Design Refinement/Environmental Re-Evaluation Memo

**I-43: Brown Street to Capitol Drive
City of Milwaukee
Milwaukee County**

**Project ID: 1228-22-00
September 13, 2022**

Subject: I-43: Brown Street to Capitol Drive, Project Design ID: 1228-22-00

PROJECT NO: 1228-22-70	HWY: IH 3	COUNTY: MILWAUKEE	PROJECT OVERVIEW	SHEET	E
------------------------	-----------	-------------------	------------------	-------	---

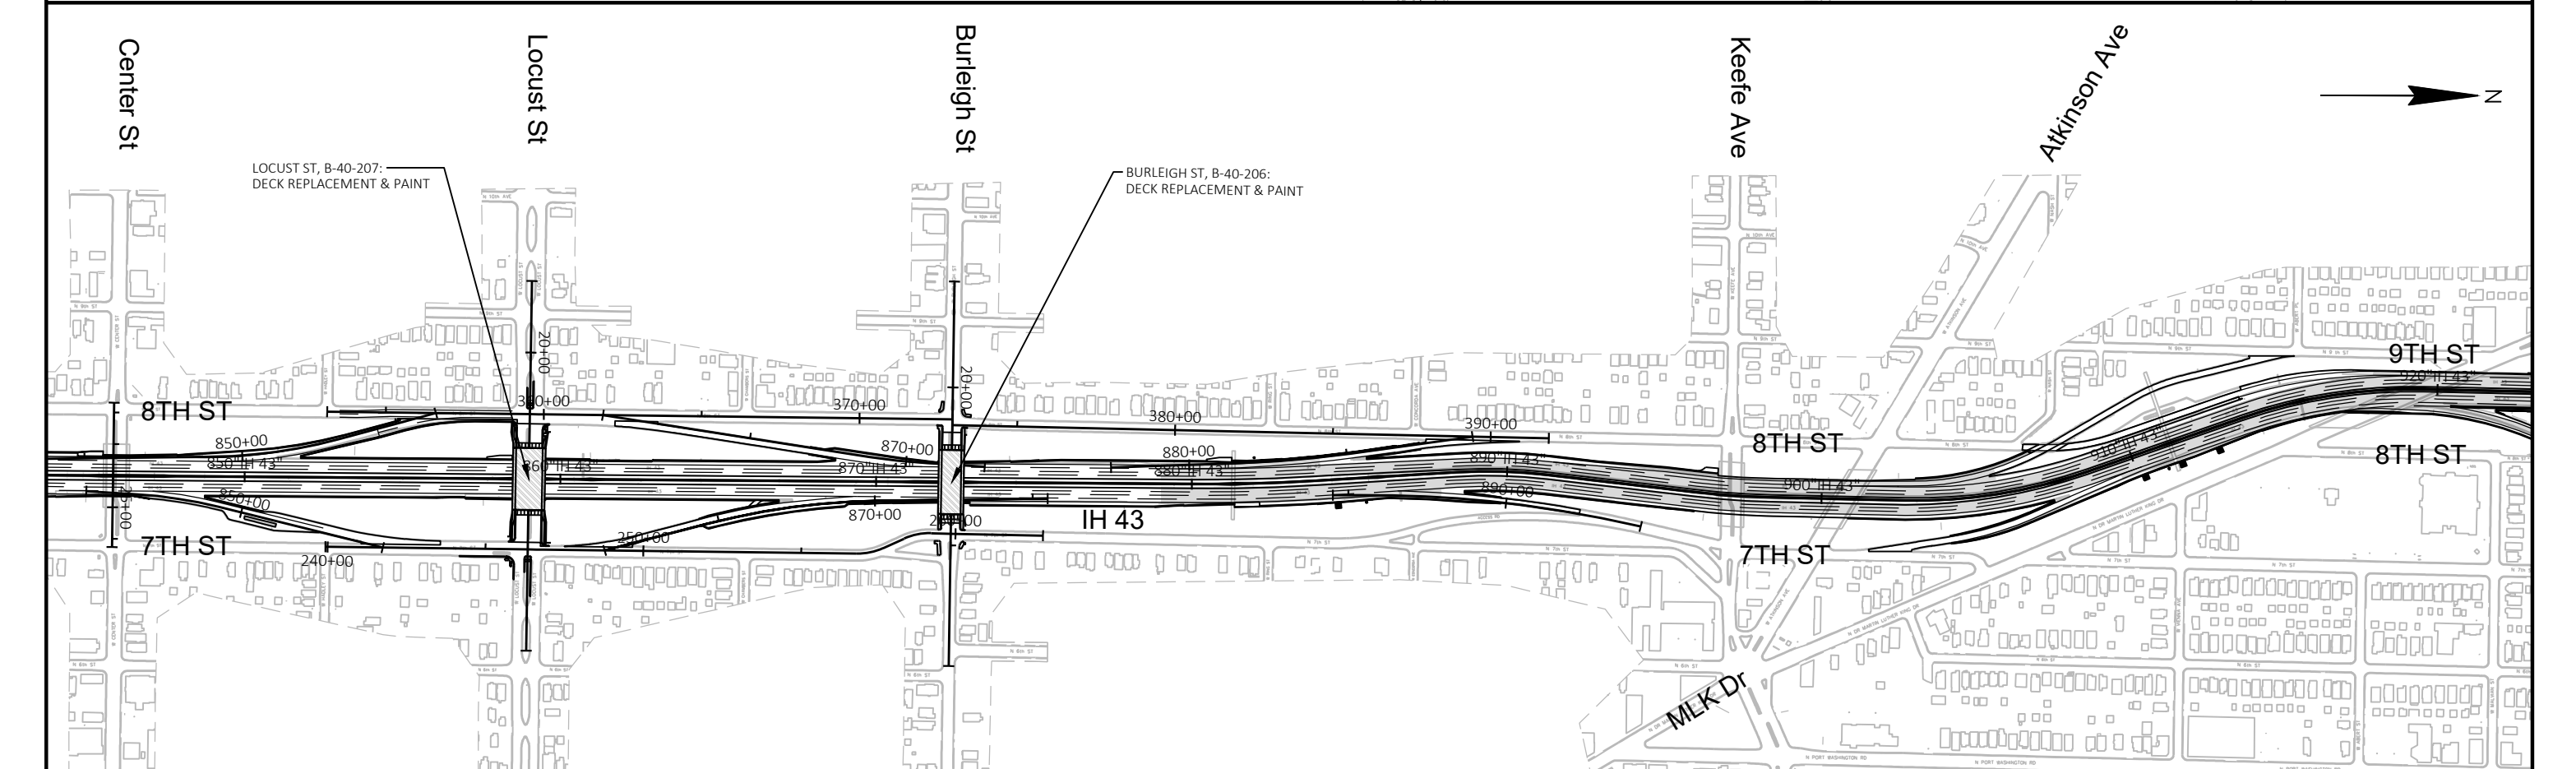
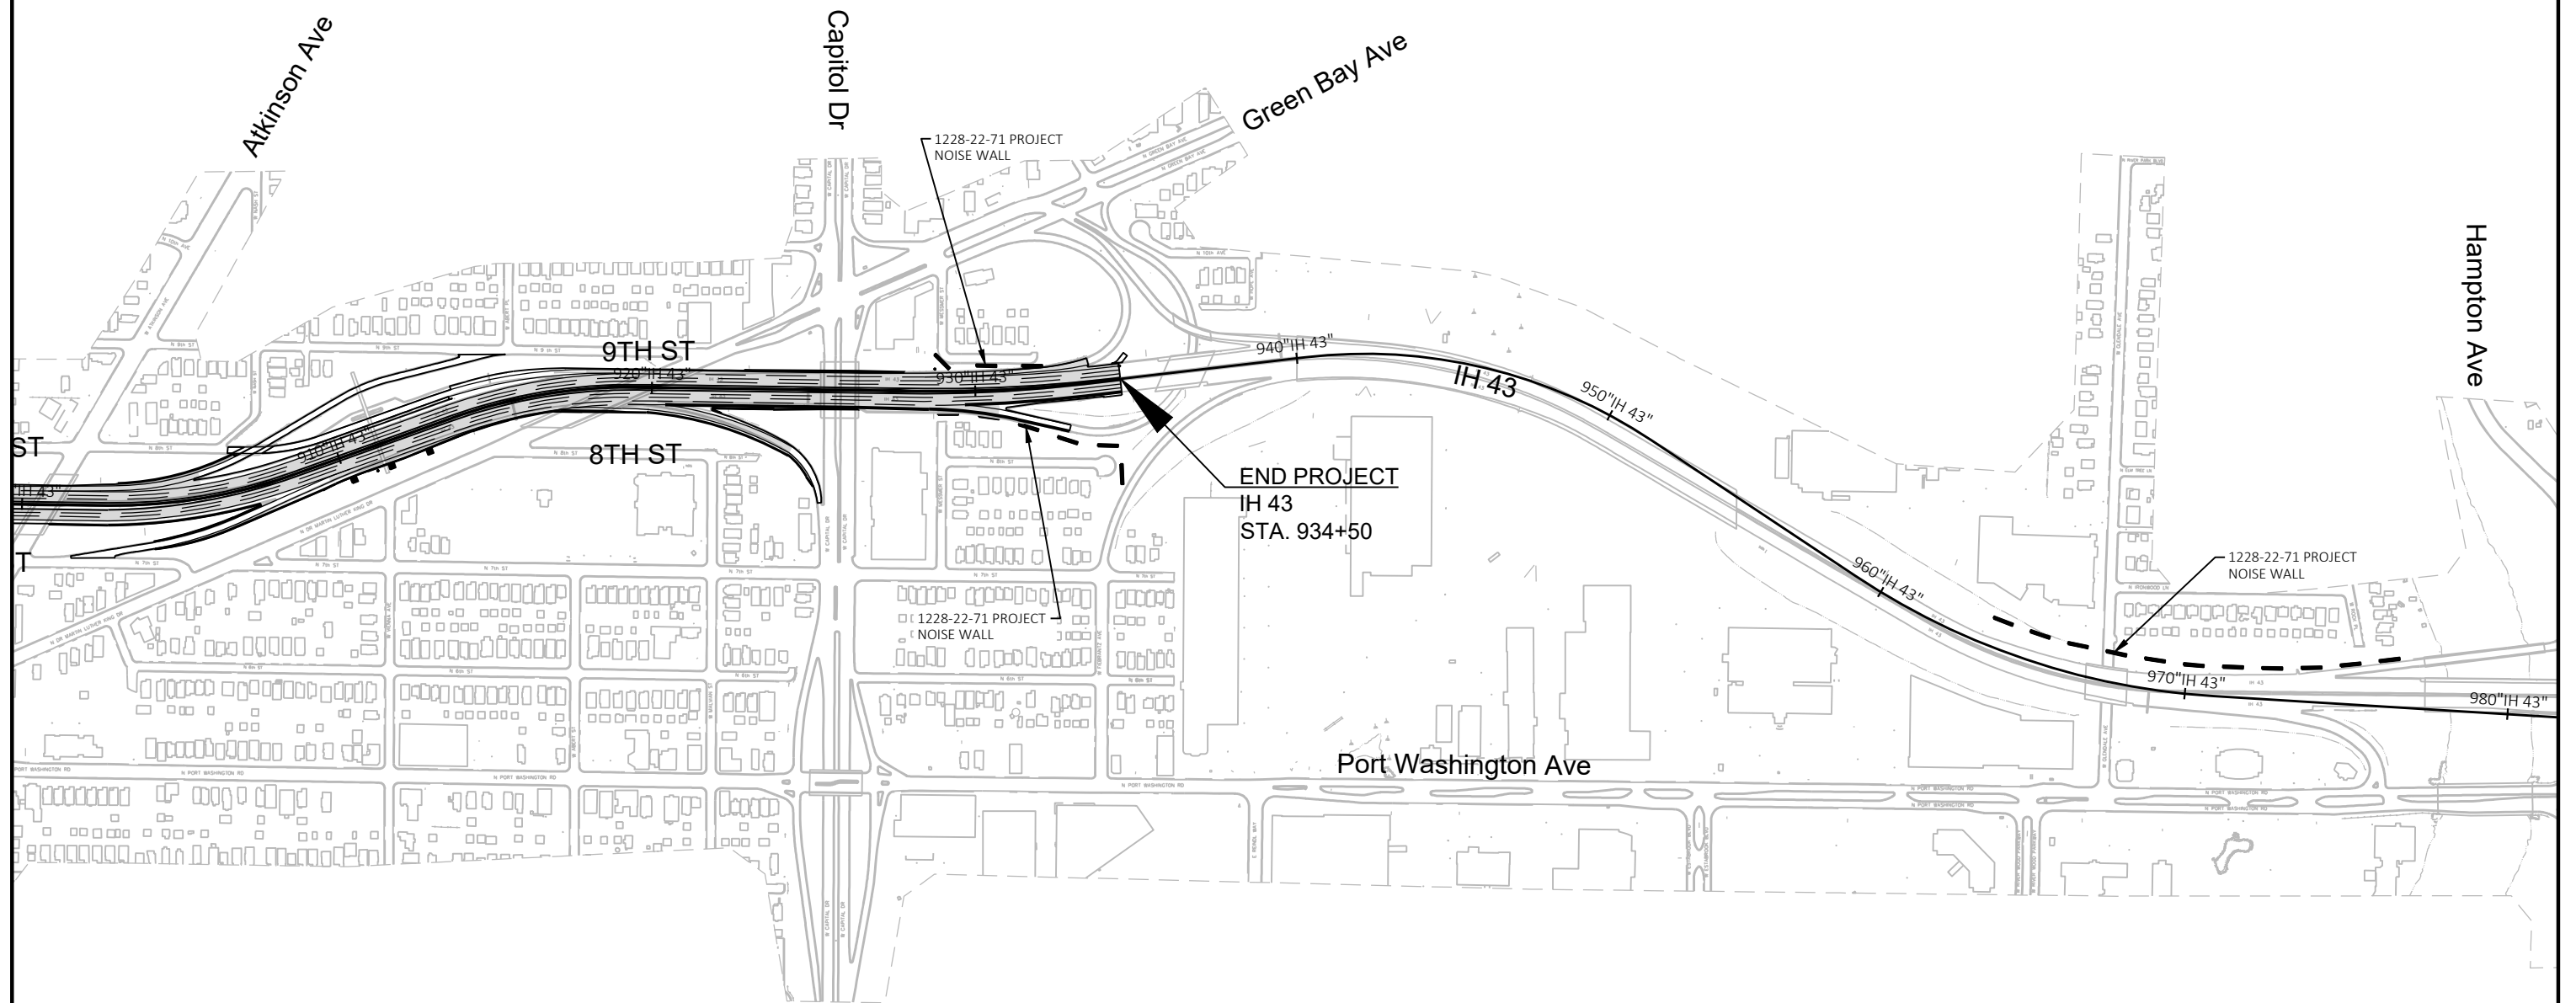
The original plan set overview sheet from the ER and a revised version with the complete scope are attached as Exhibit 1. More detailed plan sheets, consisting of the original provided in the Section 106 amendment and revised plan sheet, are attached in Exhibit 2.
